U-603282
8E.100a

Subject: Clinton Power Station Proposed Amendment of
Facility Operating License No. NPF-62 (LA-98-013)

Revision of the RPS Electric Power Monitoring Assembly Overvoltage and Undervoltage Allowable Values

NSPS SOLENOID POWER
(RPS SOLENOID POWER)

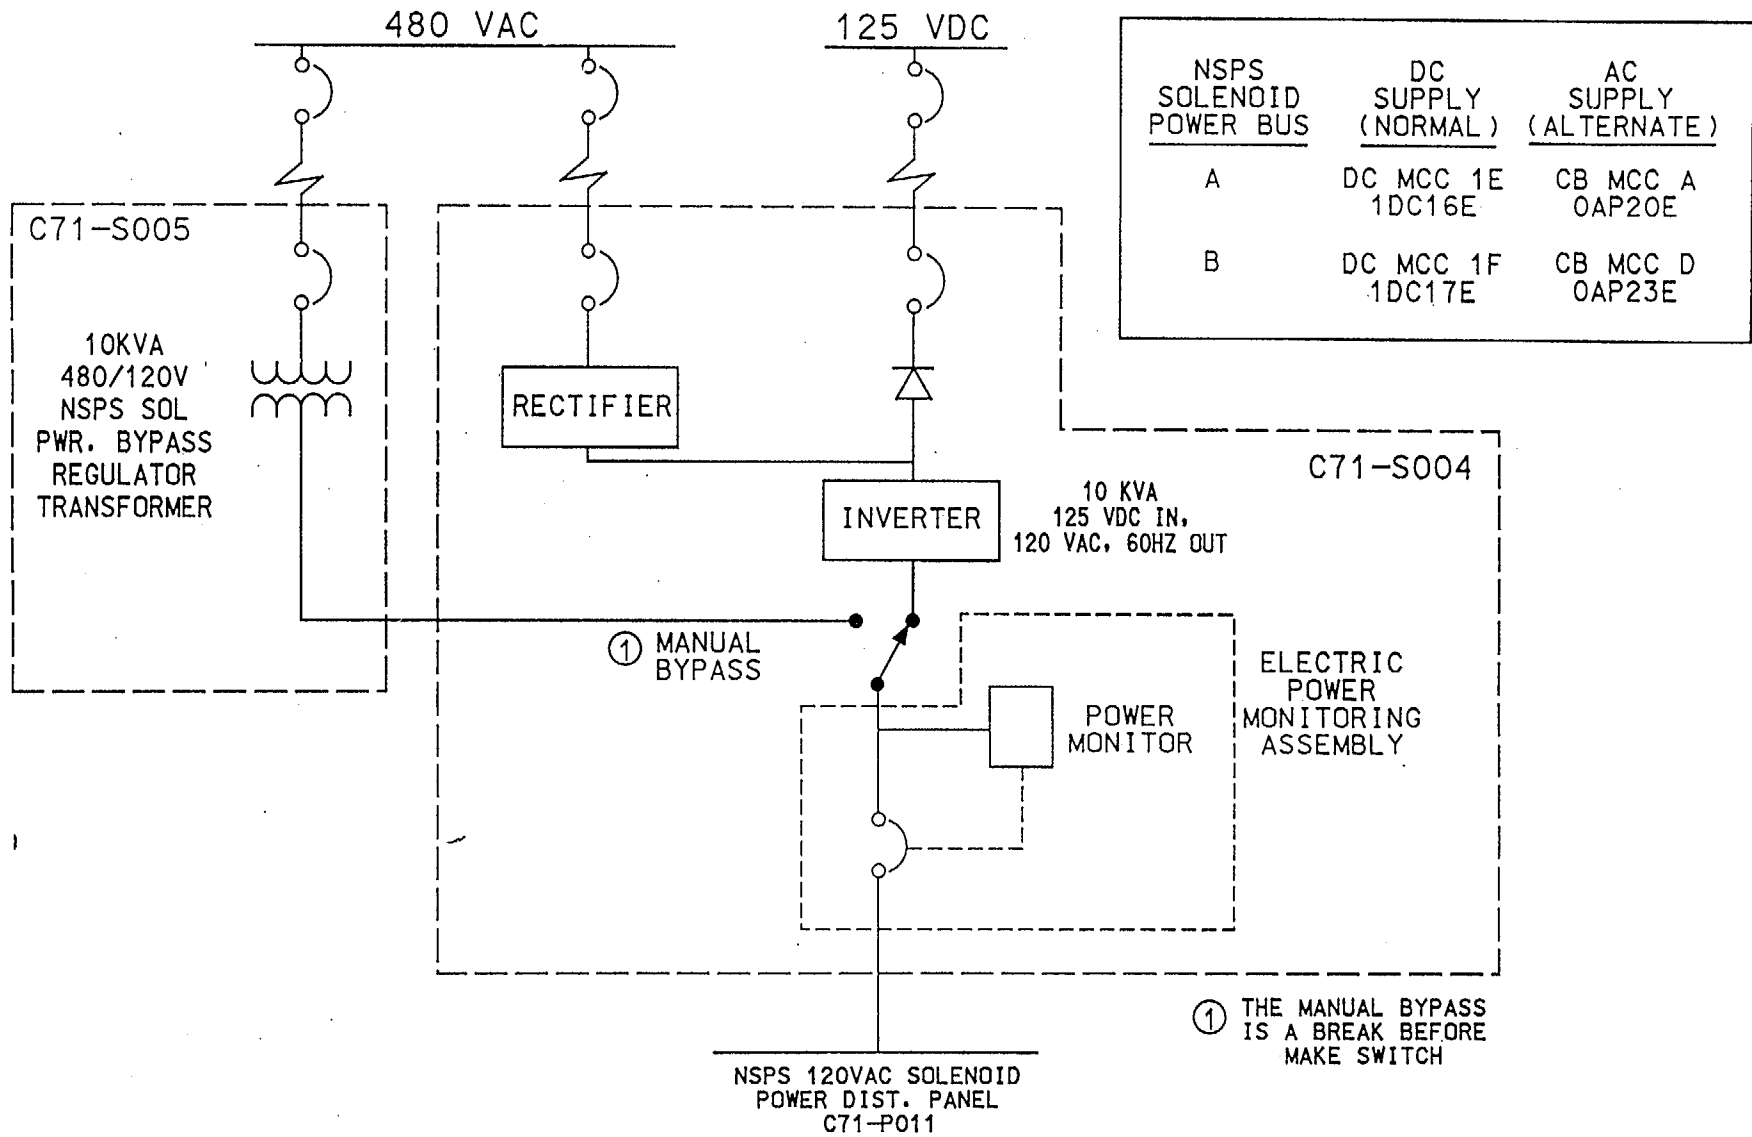
The non-divisional portion provides power to the RPS solenoid buses and is configured similar to the divisional portion. The RPS solenoid bus power supplies also have a normal and alternate lineup. The normal (preferred) lineup is via the UPS and consists of a Class 1E, DC-to-AC power inverter fed from a non-Class 1E battery and associated 480-to-120 VAC charger, or non-Class 1E source. The alternate supply is from a Class 1E-qualified regulating transformer fed from the same non-Class 1E bus as the battery charger. The inverter output includes a Class 1E-qualified power monitor system which, independently of the inverter, trips the RPS bus supply output breaker upon sensing overvoltage, undervoltage, overfrequency, or an underfrequency condition during either normal operation from the inverter or bypass operation from the alternate source. The power monitoring circuit and breaker combination is typically referred to as an electric power monitoring assembly. [See attached figure.]

The proposed change revises the Allowable Values for RPS Electric Power Monitoring Assembly overvoltage and undervoltage trip functions. Since these values are specified in Surveillance Requirement (SR) 3.3.8.2.2 of the CPS Technical Specifications, SR 3.3.8.2.2 would be revised to reflect the new values as follows:

Current SR 3.3.8.2.2 Allowable Values

- a. Overvoltage
Bus A ≤ 134.2 V
Bus B ≤ 133.6 V
- b. Undervoltage
Bus A ≥ 114.2 V
Bus B ≥ 113.2 V

Proposed SR 3.3.8.2.2 Allowable Values

- a. Overvoltage
Bus A ≤ 127.3 V
Bus B ≤ 126.7 V
- b. Undervoltage
Bus A ≥ 115.0 V
Bus B ≥ 114.7 V
